MONTGOMERY COUNTY PLANNING DEPARTMENT
THE MARYLAND-NATIONAL CAPITAL PARK AND PLANNING COMMISSION

MEMORANDUM

REVIEW TYPE: Site Plan Amendment
PROJECT NAME: Middlebrook Industrial Park
CASE #: 82003021A
APPLYING FOR: Site plan amendment to adjust building architecture, driveway and entrance locations, outdoor vehicle display areas, landscape plan, and site development table.
REVIEW BASIS: Div. 59-D-3.7.
ZONE: I-1
LOCATION: Southeast intersection of Amaranth Drive and Middlebrook Road.
MASTER PLAN: Germantown

Approved Architecture

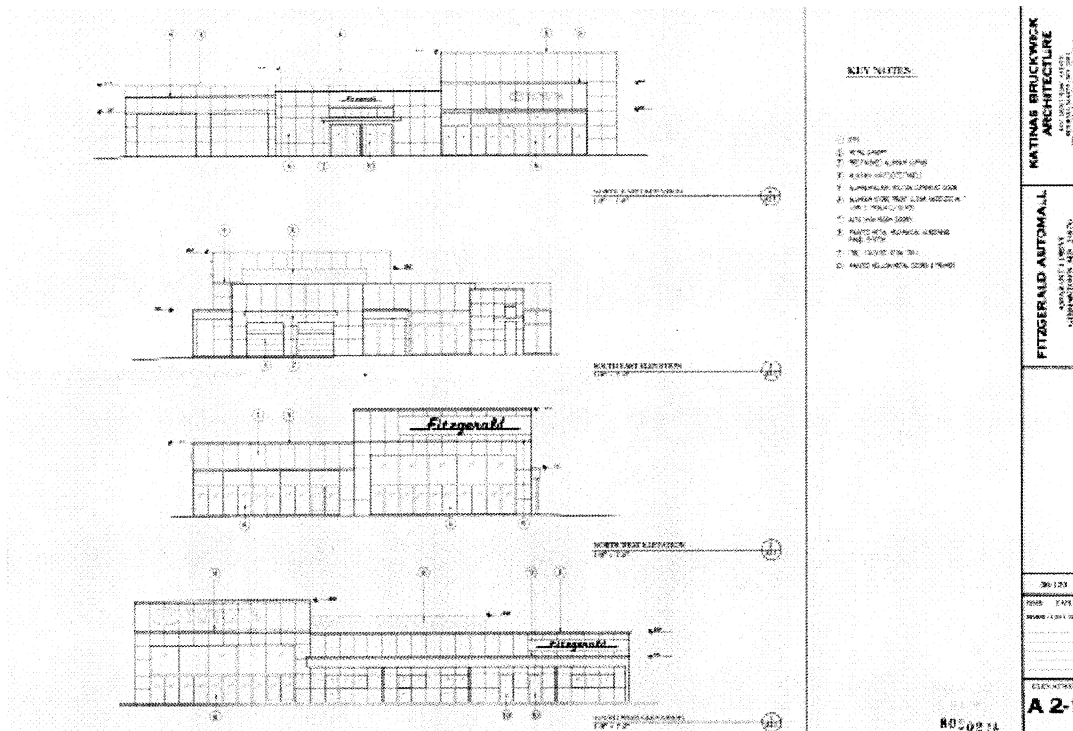
1. New auto sales, service, and office building.
 - The proposed building has been revised to a 7,645 square foot rectilinear design. This is in contrast to the 7,596 square foot modified half-circle building that was approved for Phase II.
 - The building height measuring point has changed to reflect new methods of building height determination. This has resulted in an increase to 31 feet from the approved 30 feet.
2. Revised driveways/entrances and lead walk locations.
 - The driveway to the optional service area has been realigned in conformance with the new architecture.
 - The sidewalks providing access to the proposed building have been revised from the approved layout in conformance with the new architecture.

3. Revised outdoor vehicle display areas.
 - The vehicle display areas for the proposed building now front along the interior parking lot and Middlebrook Road. The approved building's vehicle display areas were primarily along Amaranth Road.

Architecture in Proposed Amendment

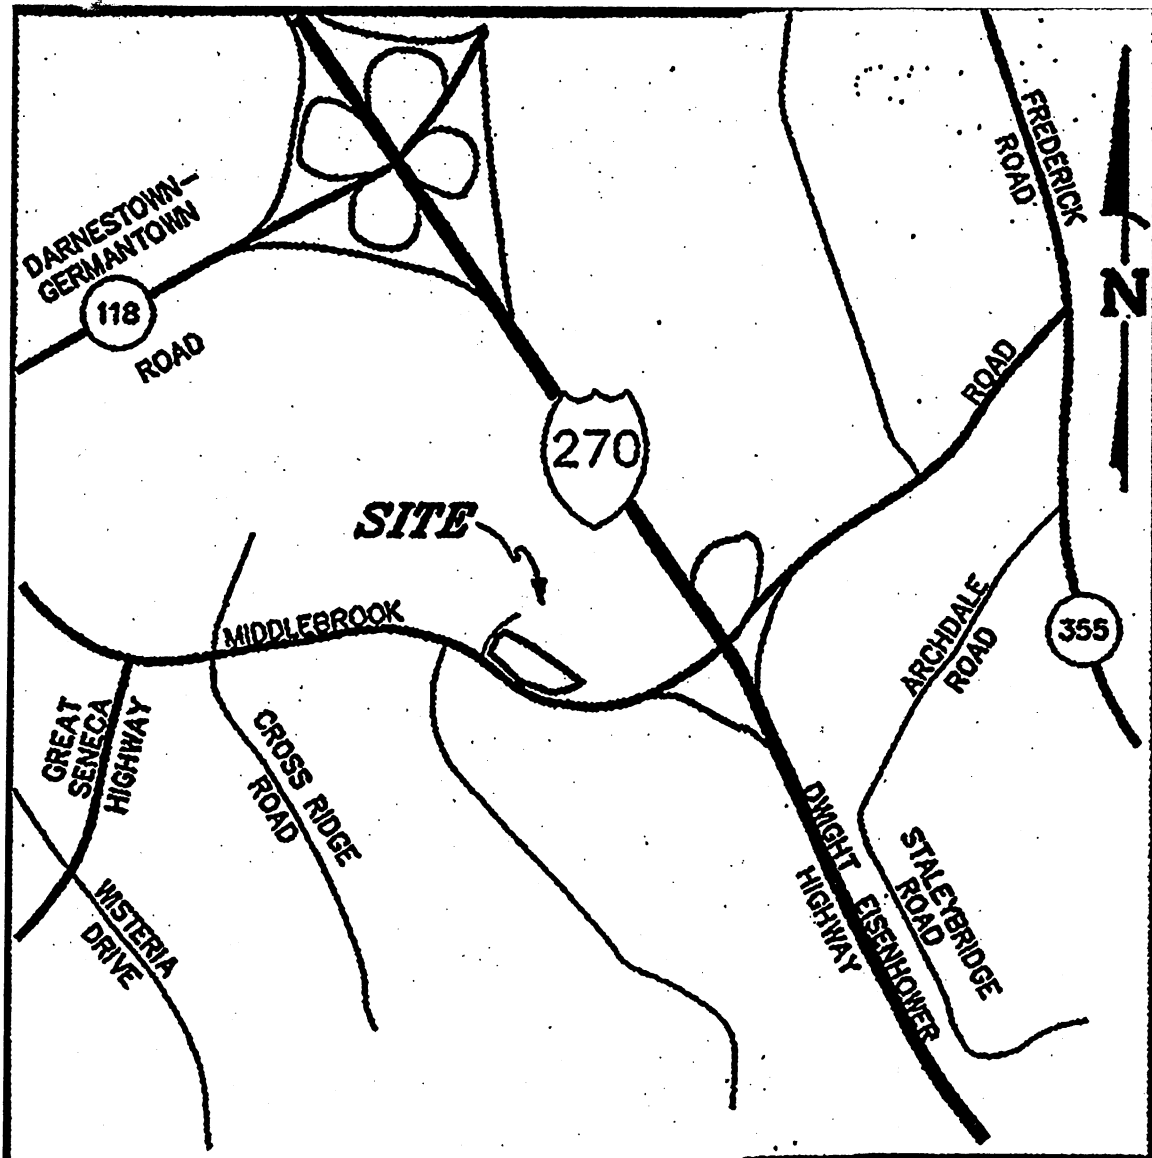
4. Revised landscape plans.
 - Plantings have been revised to remain integrated with the site and the revised architecture and vehicle display areas.
 - Trees have been added to the interior parking island.
5. Revised site development table.
 - Associated changes to the “Site Tabulation (Phase Two)” have been recorded on the Amended Site Plan to reflect the changes discussed in Section 1.
